**To:** Cumberland Planning Board  
**From:** Carla Nixon, Town Planner  
**Date:** April 4, 2019  
**Subject:** Amendment to Major Site Plan - Friends School - Route 1

Subject: Peer Review for Friends School of Portland  
Site Plan Application Amendment  
11 U.S. Route One, Cumberland, Maine

C2.0

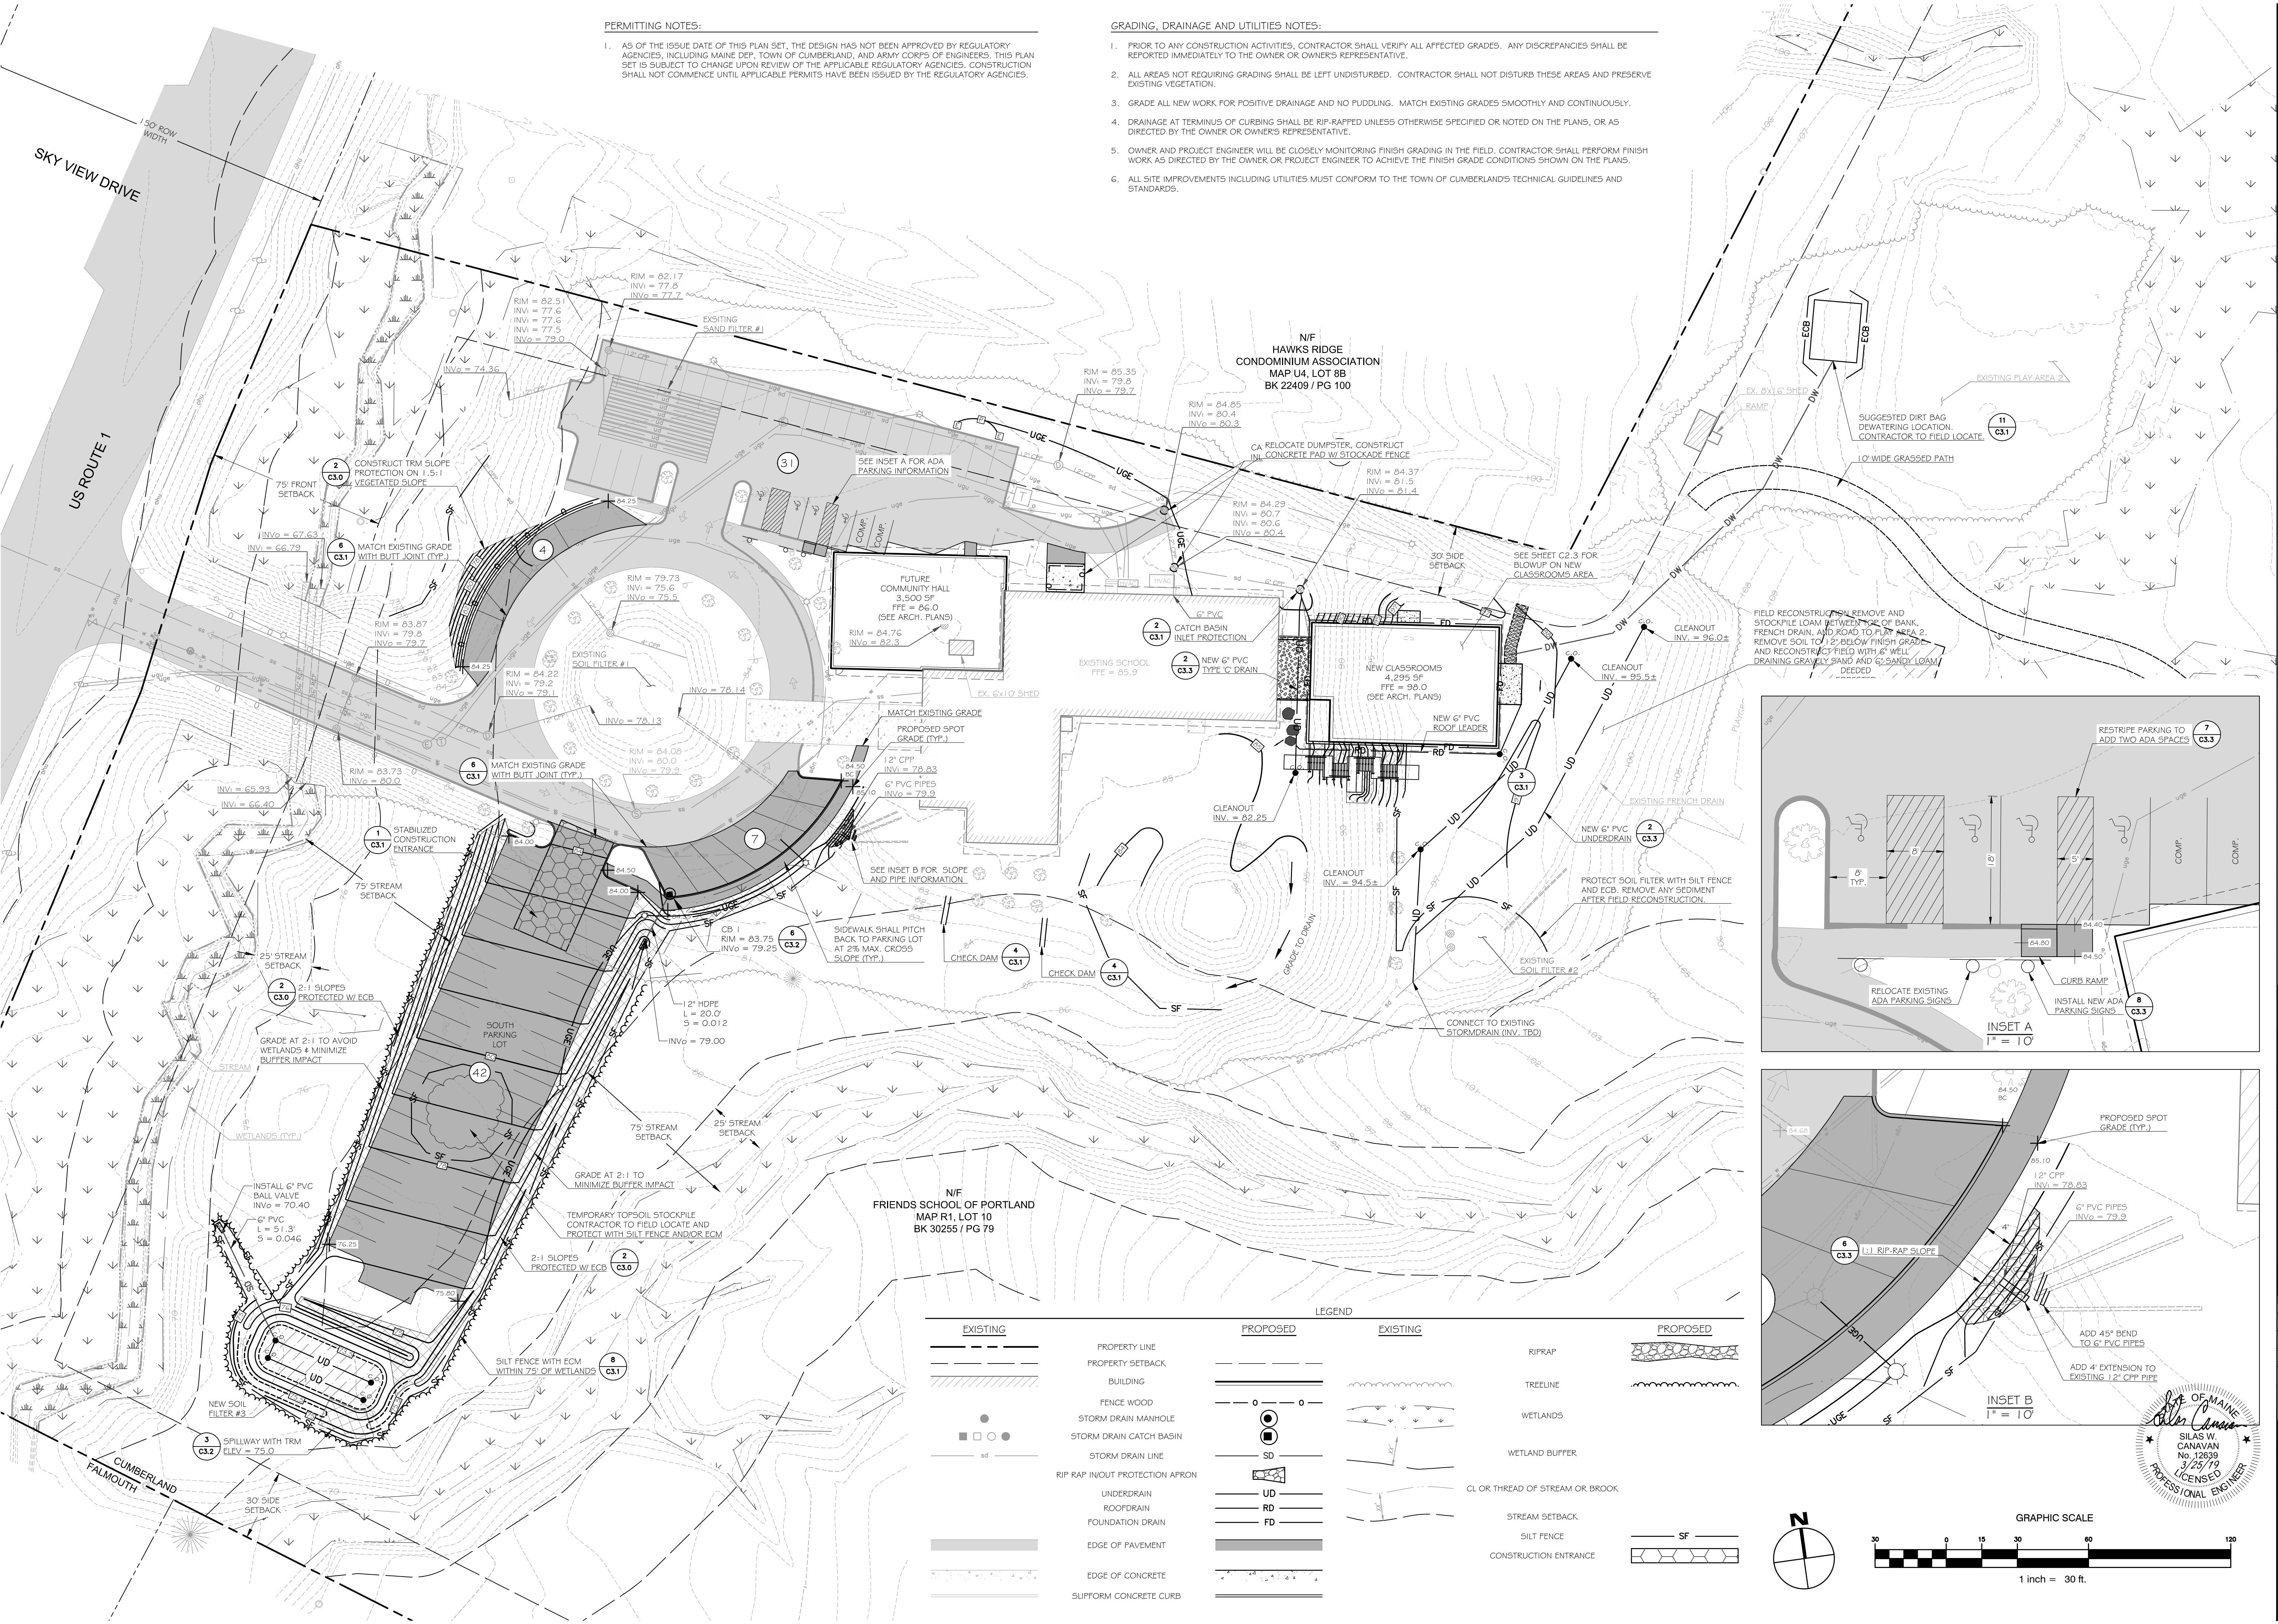
2. Please provide additional spot grades for the existing pavement at the two new ADA parking spaces north of the building. It is unclear if the slope of the existing pavement is below the 2% maximum slope for accessible spaces.

3. SME recommends the applicant add a stop bar and a one-way sign where the proposed southern parking lot intersects with the one-way turnaround.
4. Please provide a formal determination from the MEDOT or traffic engineer confirming that the increase in students and teachers will not require an amendment to the traffic movement or driveway entrance permits.

3. Please revise the Post Development Drainage Plan, D2.0 with the proposed pavement, storm drainage, and grading.
4. The invert of the 4" underdrain shown on sheet C-2.1 is listed at 72.75. This would place the pipe 6" below the bottom of the soil filter. Please revise the invert to match the detail for Underdrained Soil Filter #3.
